2022/5249/P - 32-34 Rosslyn Hill

Delegated Report		Analysis sheet		Expiry Date:	05/07/2023
		N/A / attached		Consultation Expiry Date:	26/02/2023
Officer			Application Number(s)		
Obote Hope			2022/5249/P		
Application Address			Drawing Numbers		
32-34 Rosslyn Hill London NW3 1NH			Refer to draft decision notice		
PO 3/4	Area Team Signature	C&UD	Authorised Officer Signature		
Proposal(s)					
Installation of 5 x condenser units within an acoustic enclosure together with 2 x air ventilation units and associated ductwork on the roof of the rear two storey extension.					
Recommendation(s):		Grant Planning Permission Subject to Conditions			
Application Type:		Full Planning Permission

Installation of 5 x condenser units within an acoustic enclosure together with 2 x air ventilation units and associated ductwork on the roof of the rear ground floor extension.

Image 4. Proposed roof plan

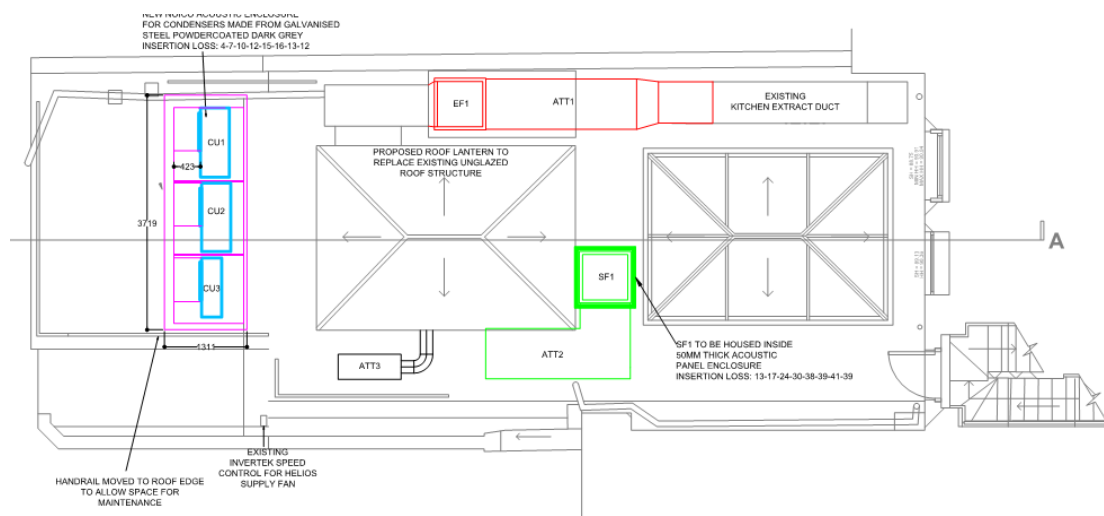
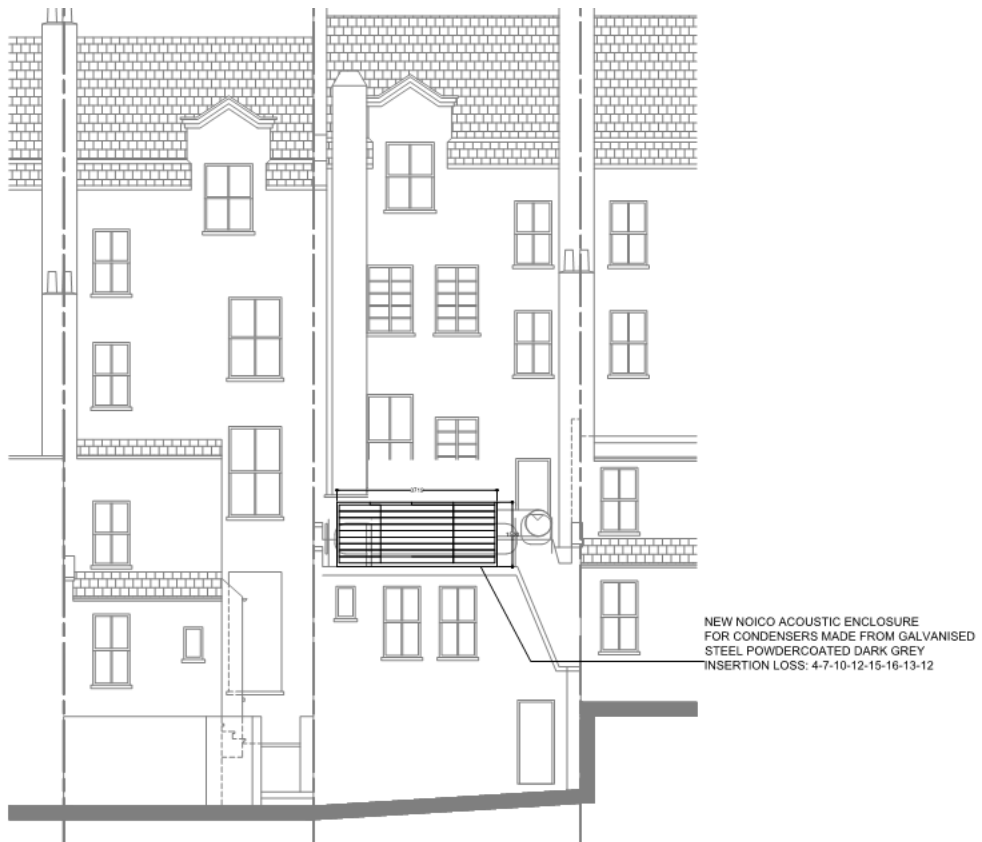
1.2 Planning permission is now sought for the Installation of 5 condenser units within an acoustic enclosure measuring 3.79m in width and 1500 in height together with 2 air ventilation units and associated ductwork on the roof of the rear two storey extension. This application has sought to address the previous reasons for refusal around lack of a Cooling Hierarchy Compliance and the impact of the air condenser units on the neighbouring residential amenity.

- Reduction in height of the acoustic screen by 988mm from 2488mm to 1500mm.

2.2. It should be noted that reduction in height is the maximum possible so as not to affect the acoustics/noise levels of the required plant equipment.

- 3.2 The proposal involves rationalising the existing rear roof plant and installing new condenser units. The rearranged plant and new condenser units would be installed at the rear of the existing two storey rear extension. The existing condensers on the rear elevation would be relocated to the flat roof of the rear extension. The existing kitchen air handling unit, kitchen extract fan and associated ductwork would be replaced.

- 3.3 As revised the proposal introduces a new acoustic enclosure that would be visible from the alley way on Downshire Hill of this part of the property and there are some minor private views from the residential flats on upper floors of the site and neighbouring properties. However, the plant equipment and condensers already exist on the roof of the rear extension and given that there is existing plant and mechanical equipment is currently at roof level the proposal is not out of character to the host building and wider area. Moreover, the proposal is located below window height and substantially away from the rear windows of the residential units and the views would therefore only be oblique and negligible. Overall, it is considered that the proposal may cause minor harm to the visual amenities, but due to the rear location and back of the site having a plant equipment already, it is considered, on balance that the proposal is acceptable in design terms, in accordance with policy D1 of the Camden Local Plan.
